Title - Sujet Reconstruction quai Grande-Entrée	
Solicitation No. - N° de l'invitation F3731-170016/A	Amendment No. - N° modif. 002
Client Reference No. - N° de référence du client F3731-170016	Date 2017-12-01
GETS Reference No. - N° de référence de SEAG PW-\$QCM-008-17263	
File No. - N° de dossier QCM-7-40165 (008)	CCC No./N° CCC - FMS No./N° VME
Solicitation Closes - L'invitation prend fin at - à 02:00 PM on - le 2017-12-13	
F.O.B. - F.A.B. Plant-Usine: <input type="checkbox"/> Destination: <input checked="" type="checkbox"/> Other-Autre: <input type="checkbox"/>	
Address Enquiries to: - Adresser toutes questions à: Rochette, Jean	Buyer Id - Id de l'acheteur qcm008
Telephone No. - N° de téléphone (418) 649-2834 ()	FAX No. - N° de FAX (418) 648-2209
Destination - of Goods, Services, and Construction: Destination - des biens, services et construction:

AMENDEMENT 002

Title: THE DEMOLITION AND RECONSTRUCTION OF WHARVES 401 TO 405 OF THE FISHING HARBOUR OF GRANDE-ENTRÉE IN THE MAGDALEN ISLANDS, QC

1. Solicitation closing date extension
2. Questions and answers 7 to 38

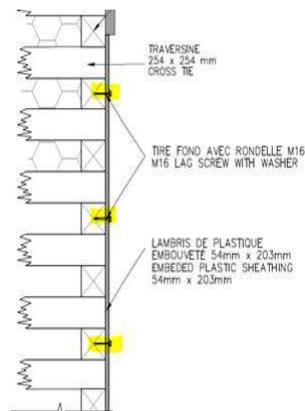
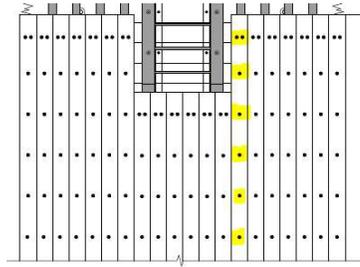
Question 32: For the fastening of the underwater sheathing (M16 lag screw), there is an inconsistency between the sheathing section and the typical detail of ladders and sheathing

We can see that on the sheathing section, the lag screw are installed differently than on the detail, the quantity varies and also influences the production for the installation.

Do we have to put lag screw on each row of longitudinal or we can jump a row of longitudinal between each lag screw?

Answer 32: Lag screw at each longitudinal or crosstie

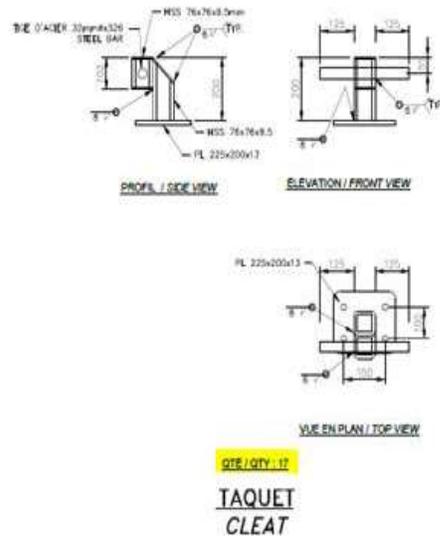
Question 35: On the detail of the cleats on sheet 21, it is indicated a quantity of 17 cleats.

But on tender form it is indicated 125. Are there several types of cleats?

Answer 35: There are 125 cleats to provide and install, one type.
